Project Name: Runway 3/21 Extension – New Exit Twy, Twy Repairs, and Perimeter Rd Reconstruction – Re-Bid at San Antonio International Airport

Project No. 33-00160

Date: February 27, 2013

Addendum No. 4

PROJECT LIMITS PLAN

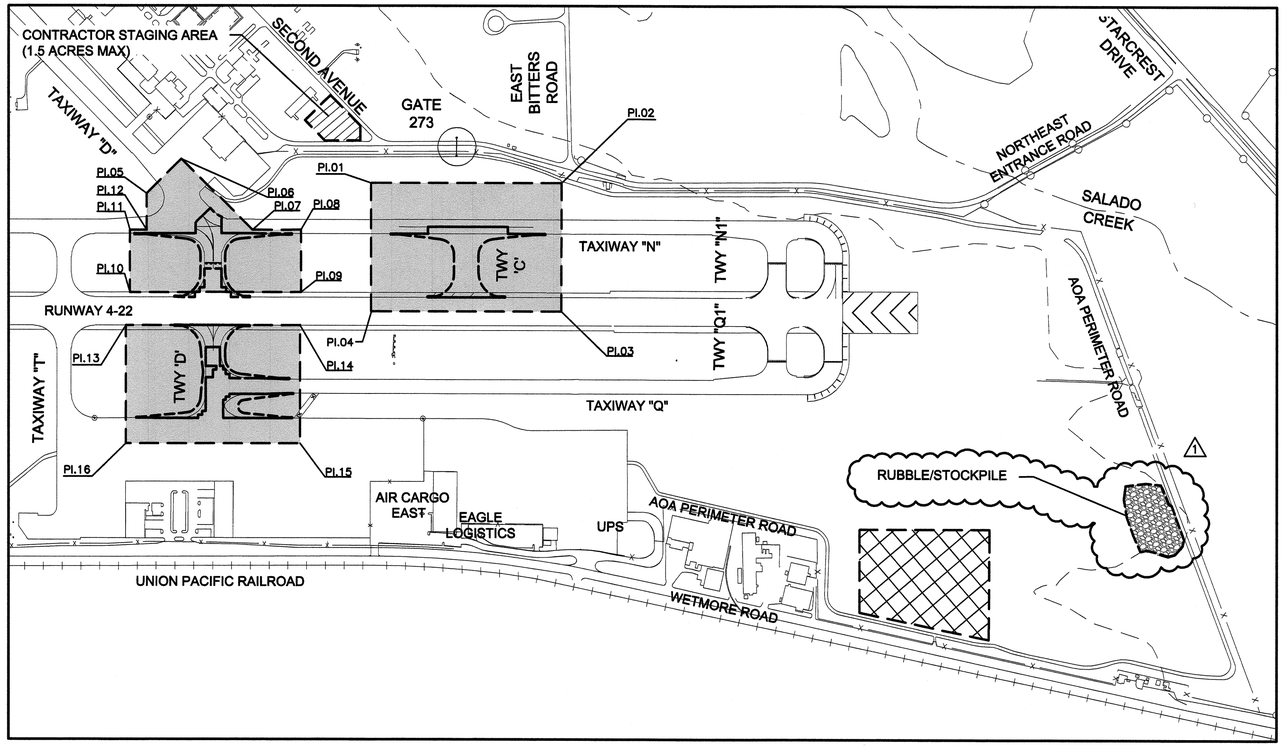
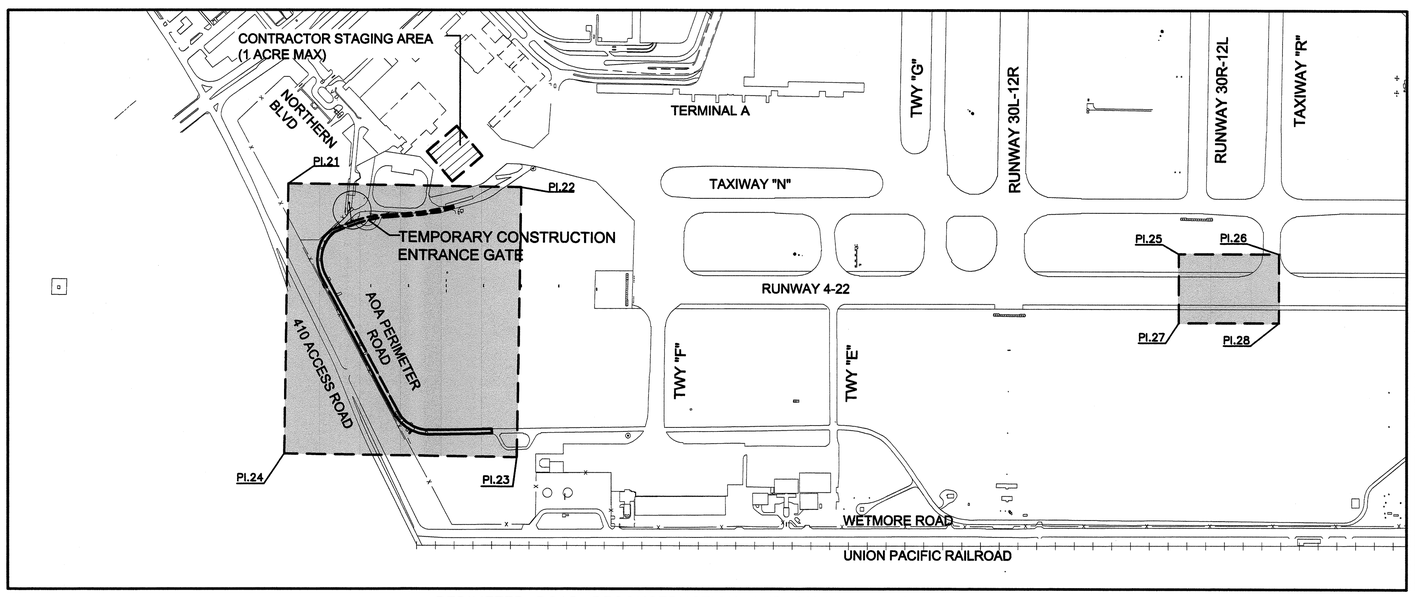
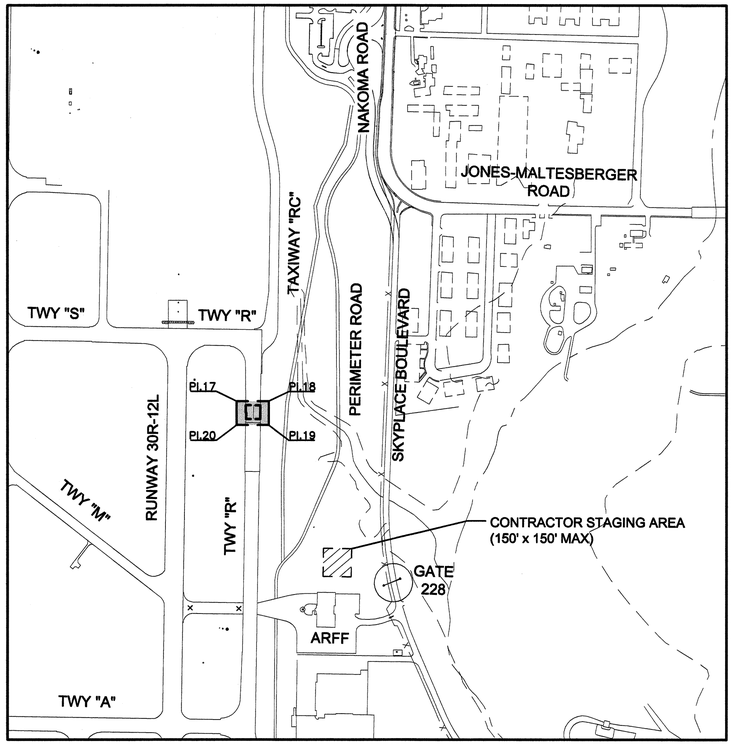
1. Sheet C-001 Project Limits Plan
   Added location of rubble/stockpiles.
